DRAINAGE PLAN

The construction of the Camino Real Addition paving did not follow the grades shown on the approved grading and drainage plan. The as-built elevations are shown hereon to demonstrate that Basin 1 freely discharges via the existing drivepad to Yale Boulevard S.E. The approved plan called for a positive discharge pond which was not built. The pond was not built because the existing drivepad was left in place. Because of this, a standard 4-inch PVC curb penetration could not be constructed in accordance with City of Albuquerque Standard Details. Without the construction of this release point, the paving contractor attempted to discharge the runoff through the existing drivepad to Yale Boulevard S.E. In view of the minor increase experienced by this further development of Basin 1, this free discharge appears acceptable. This will result in a 0.3 cfs overall increase in runoff from Basin 1 for the 100-year, 6-hour rainfall event. The change in runoff volume will remain at 440 cf, which will have an insignificant impact on the water surface level in the adjacent street flooding. All other construction appears to be in accordance with the approved plan. No changes have been

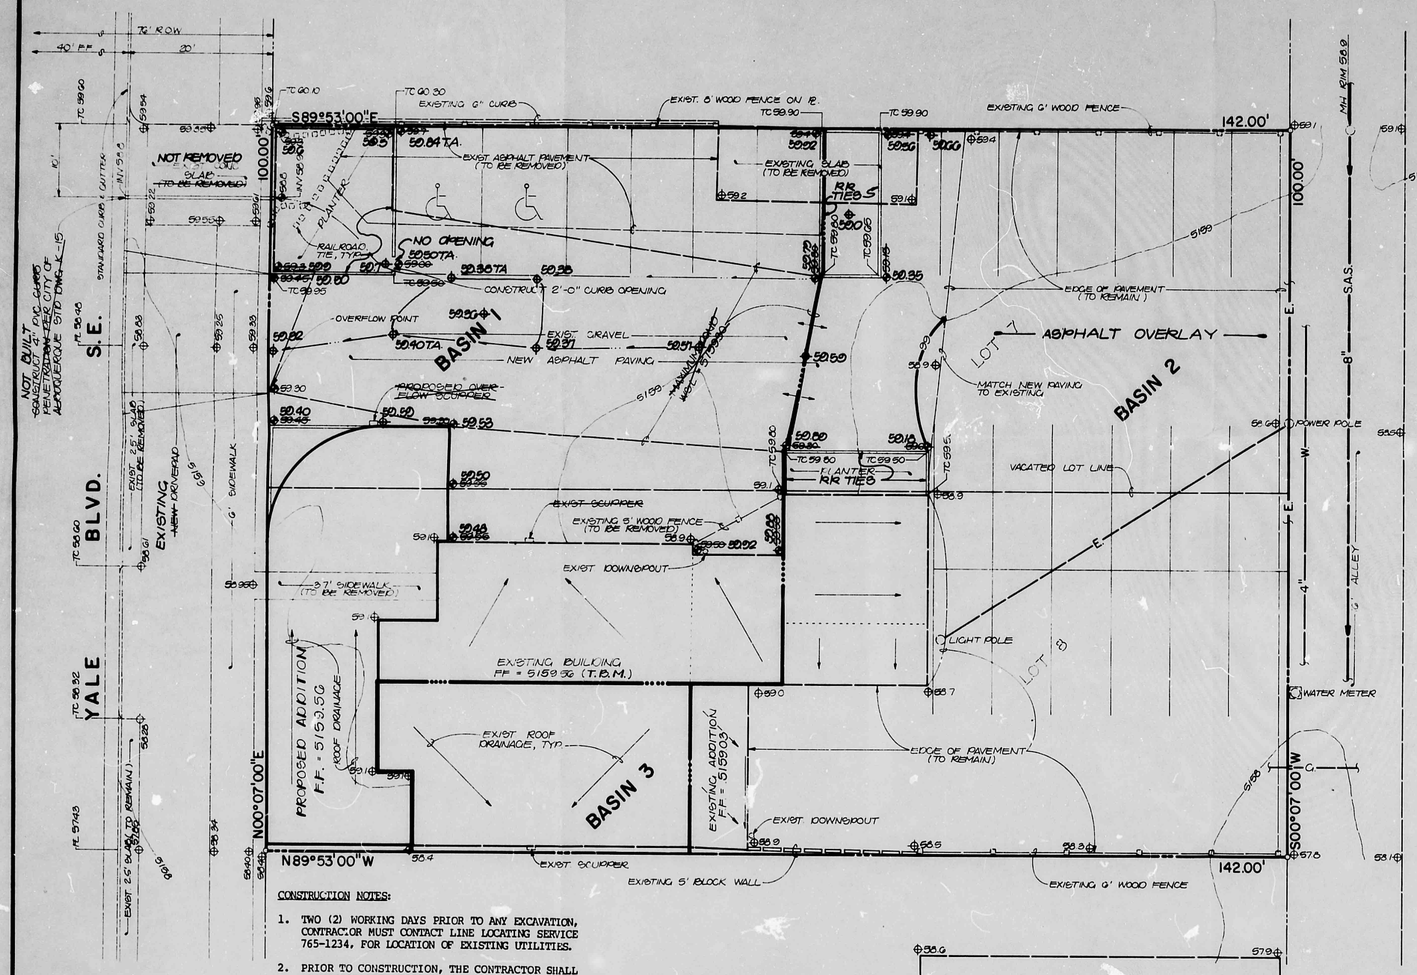
$\cancel{Q_{release} = CA\sqrt{2gh} = 0.25 \text{ cfs}}$

$\cancel{\text{where } C = 0.8}$
$\cancel{A = 0.0873 \text{ sf } (4'' \text{ dia. pipe})}$
$\cancel{g = 32.2 \text{ ft/sec}^2}$
$\cancel{h = 59.3 - 58.9 = 0.17 = 0.2'}$

$\cancel{\text{By hydrograph analysis, } V_{required} = 163 \text{ cf}}$
$\cancel{V_{pond} = \tfrac{1}{2}[(A_{58.9} + A_{59.0})(0.1) + (A_{59.0} + A_{59.3})(0.3)]}$
$\cancel{= \tfrac{1}{2}[(0 + 360)(0.1) + (360 + 1{,}780)(0.3)]}$
$\cancel{= 340 \text{ cf} > V_{required}}$

⚠ $\Delta Q_{100} = \overset{0.6}{\cancel{0.25}} - \overset{0.3}{} = \overset{0.3}{\cancel{0}}$ cfs ~~(no change)~~ INCREASE
$\Delta V_{100} = 1{,}010 - 570 = 440$ cf (increase)
